A SUBDIVISION FOR SINGLE FAMILY RESIDENCES

THE ARBORES OF FOREST PARKS

FINAL CONDITIONS OF APPROVAL

NAME OF SUBDIVISION: FOREST PARKS 10TH SECTOR

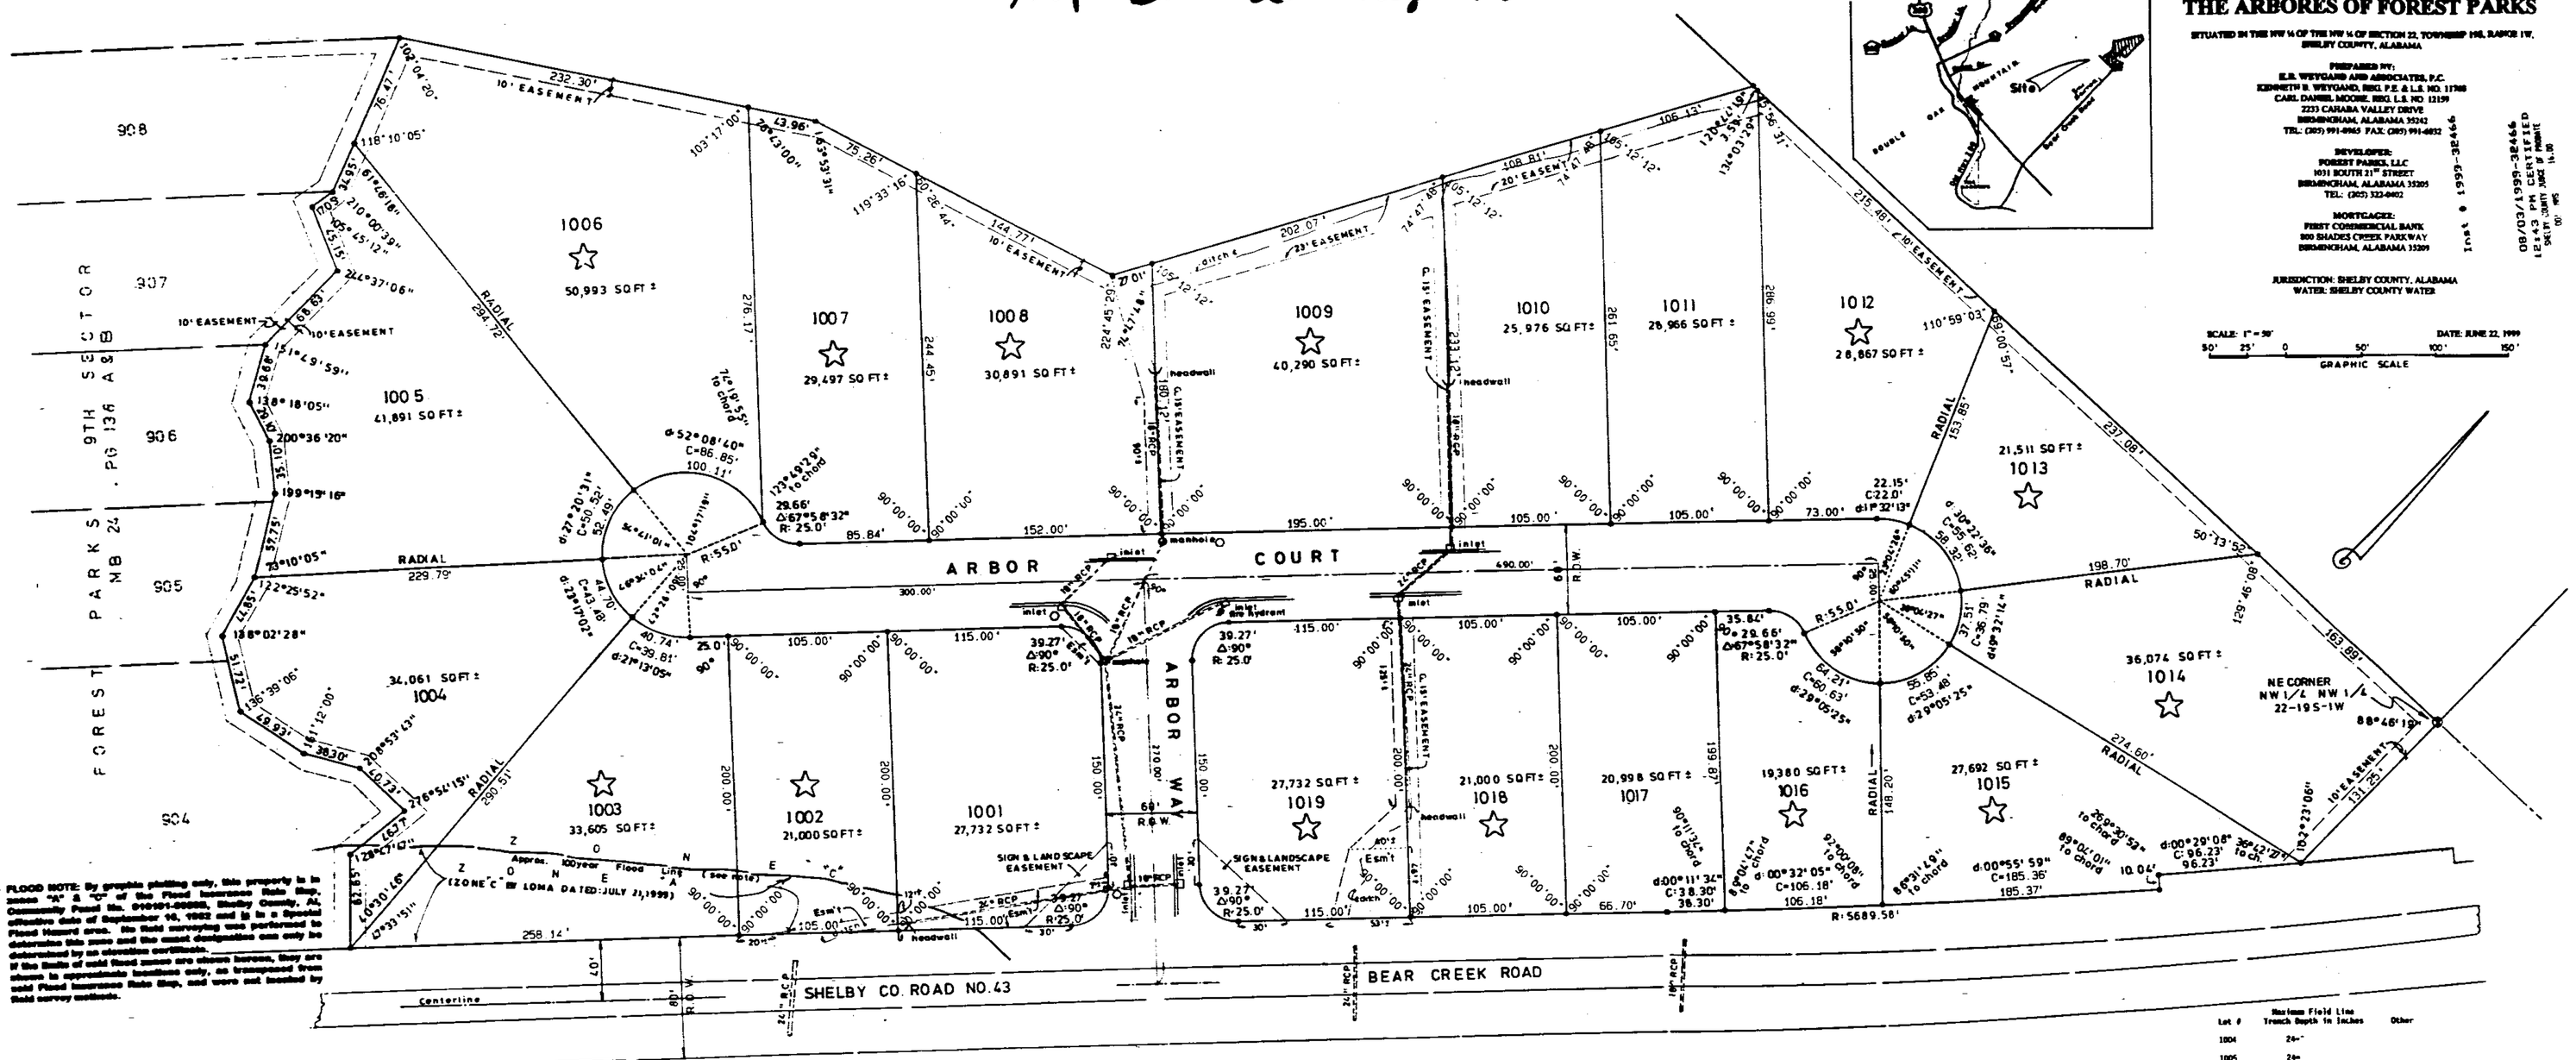
7. The comments on this report are based solely on observations of soil bores, percolation test and closely surrounding areas as lot lines were not marked nor were systems and structures plotted on the subdivision final map. The following lots are approved with the primary disposal field site located at the perc test and soil bore locations shown on the final map with the following restrictions:

Lot #	Maximum Field Line Trench Depth in Inches	Other
1001	12"	
1004	24-*	
1005	24-	
1010	24-*	
1011	24"	old road bed can not be used for field lines unless engineer certifies road bed repair
1017	12"	hard pan

* Denotes ground water observed in soil bore.
+ Ground water indicators observed in soil bore.
# Due to depth to rock.
- Restricted due to depth of perc test.
' Restricted due to certain clays, pans, fragipans or others.

8. Should the primary disposal location for any lot be relocated to another area of the lot such that the perc test and soil bore would not be within the boundary of the primary disposal field, an additional soil bore and perc test will be required. The above trench depth restrictions would be changed to represent the limitations imposed at the new site.

9. The following lots are withheld:

1002 - percolation test 90 mpi, DTRL(depth to restrictive layer) 24 inches, Tomsley soils wet season or engineer simulated wet season must be performed

1003 - percolation test 120 mpi, DTRL 32 inches, Tomsley soils, perc test invalid

1006 - DTRL 26 inches, Tomsley soils, perc test invalid

1007 - DTRL 30 inches, Tomsley soils, perc test invalid

1008 - DTRL 30 inches, Tomsley soils, perc test invalid

1009 - DRTL 26 inches, Tomsley soils, perc test invalid

1012 - slope 33%, DTRL 36 inches, Tomsley soils, perc test invalid

1013 - slope 29%, DTRL 40 inches, Tomsley soils, perc test invalid

1014 - soil bore in old road bed, DTRL 36 inches, Tomsley soils, perc test invalid

1015 - DTRL 16 inches, Tomsley soils, perc test invalid

1016 - DTRL 24 inches, Tomsley soils, perc test invalid

1018 - DTRL 8 inches

1019 - no data submitted, wet season or engineer simulated wet season percolation testing required

All lots which were noted as having Tomsley soils must have a percolation test during the wet season or be an engineer simulated wet season percolation test.

All lots withheld may be submitted to the Shelby County Health Department when either by design or relocation of sewage systems the limitations listed above have been overcome in accordance with Alabama's Onsite Sewage Disposal Rules 420-3-1. Appendix B and Appendix I of the Rules should be used to design systems to overcome limitations imposed by groundwater, restrictive layers or slopes greater than 25%.

10. The soil bore for record on each lot should remain open if this soil bore and percolation test site is located at the site of the proposed primary field line area until a permit to install an onsite sewage system for that lot has been issued.
